KCK COMMUNITY EDUCATION, HEALTH & WELLNESS CENTER

ADDENDUM #1

PGAV PROJECT #53664-00

April 15, 2024

SLAB EDGE PLAN - LEVEL 2
1/8" = 1'-0" **A1**

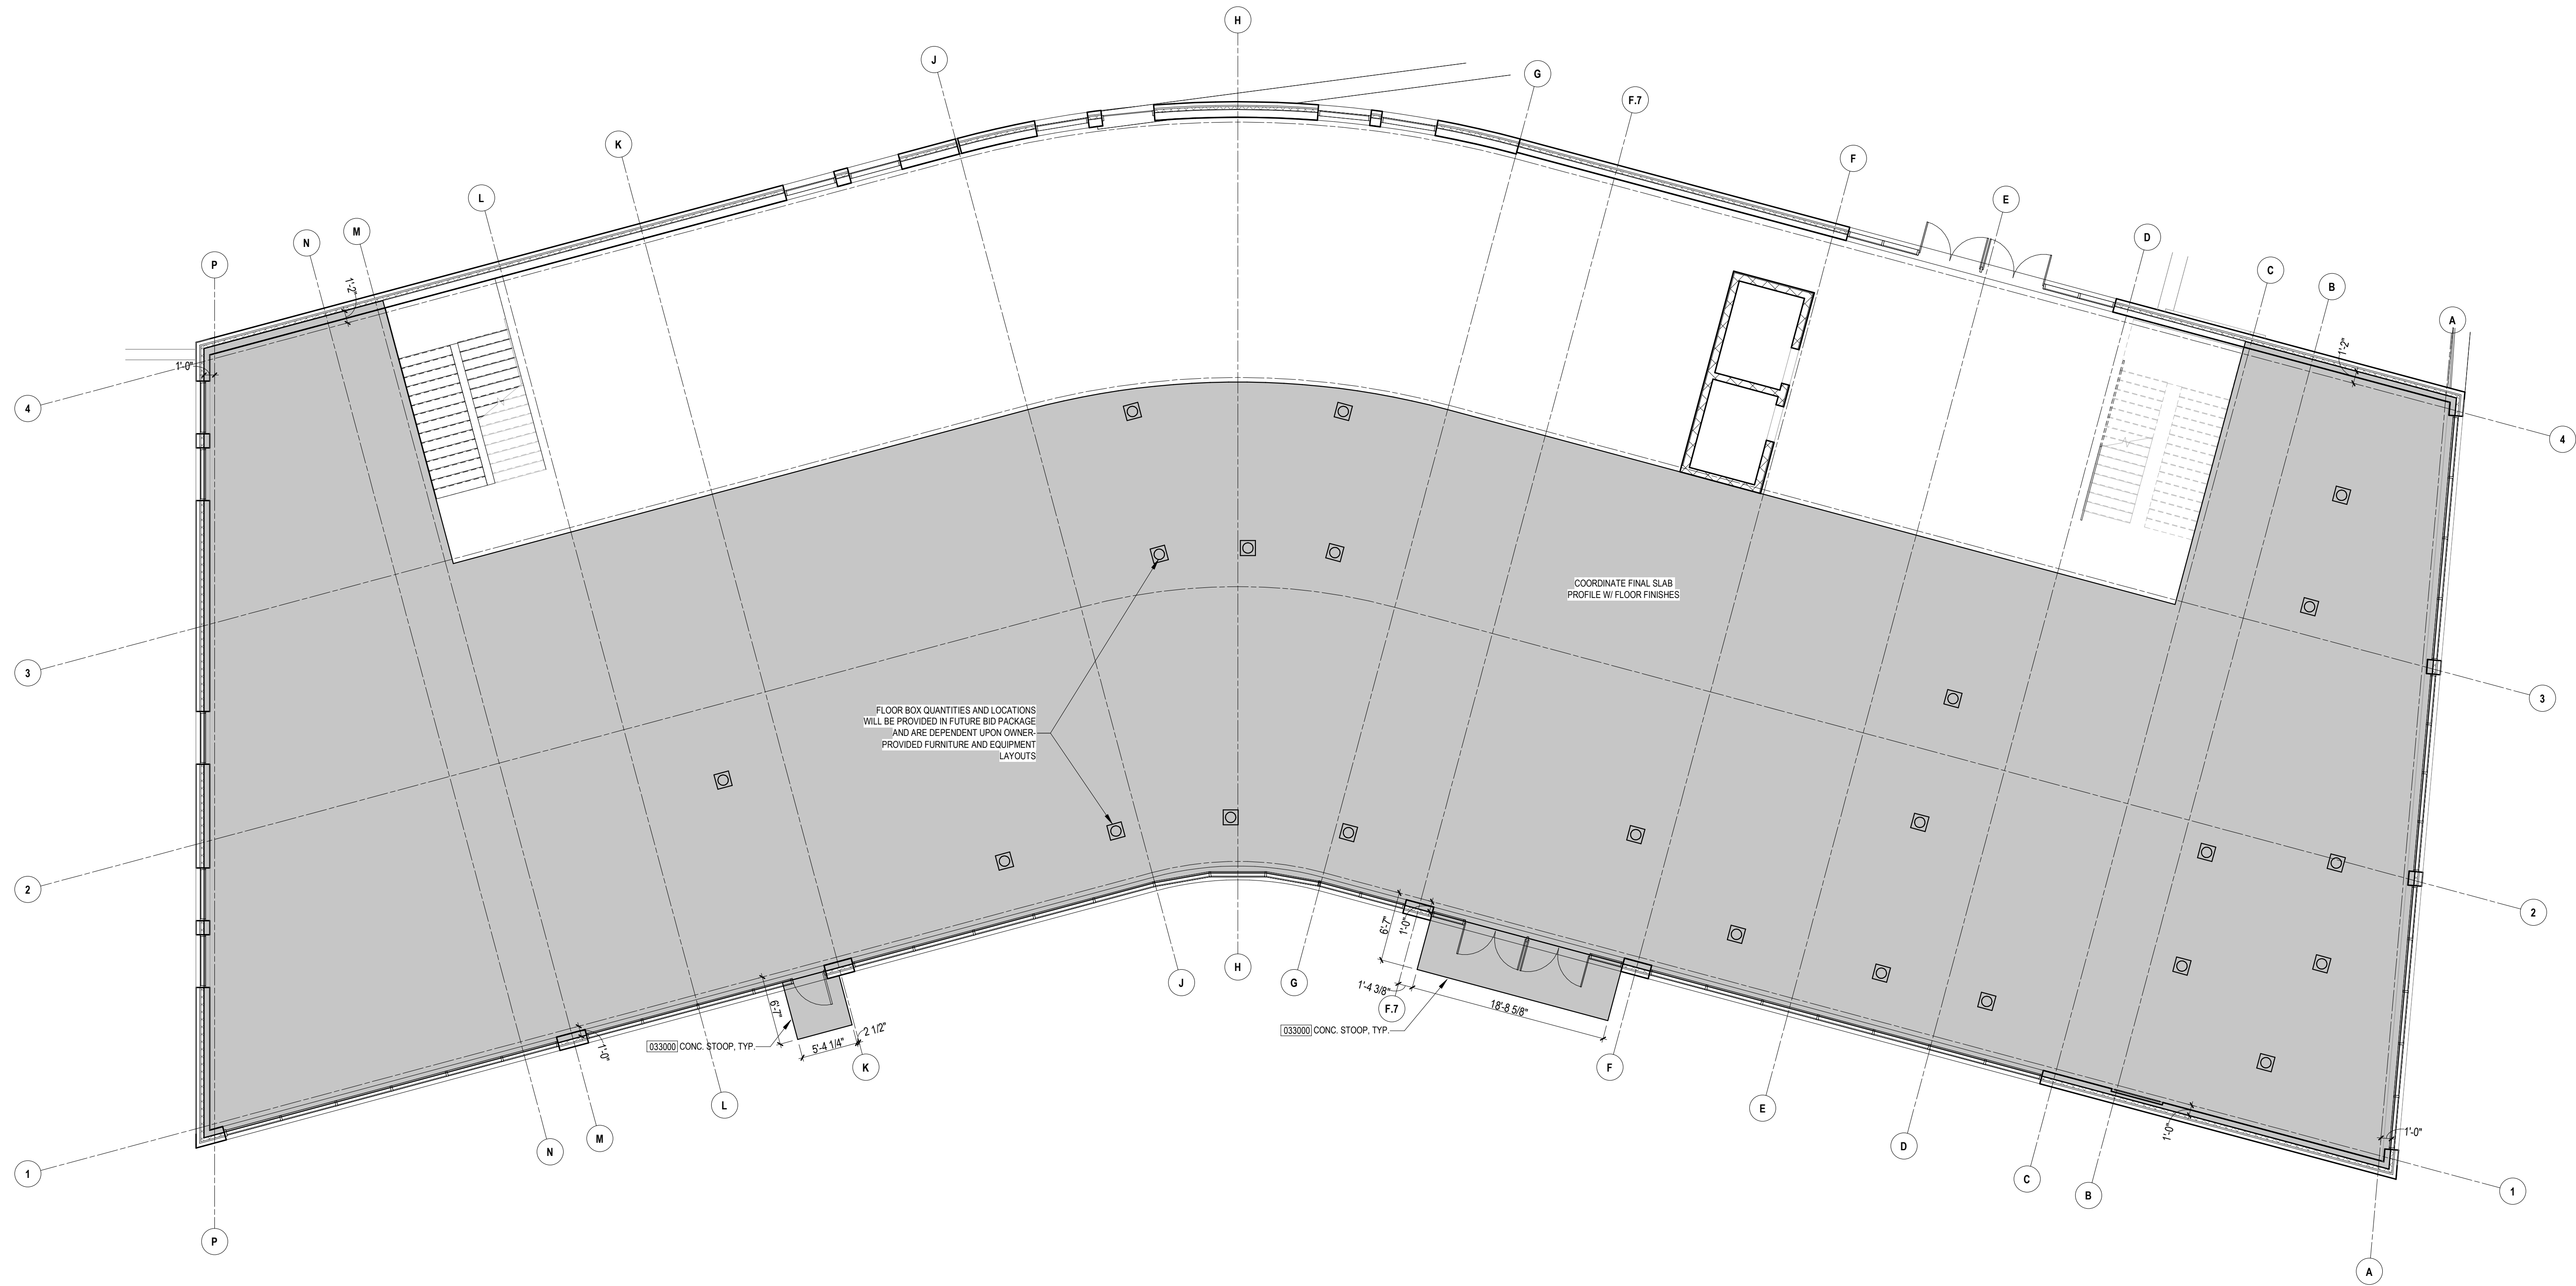
1. Refer to the attached revised sheet with revisions dated 4/15/2024:
 - a. Clarified edge of slab locations.
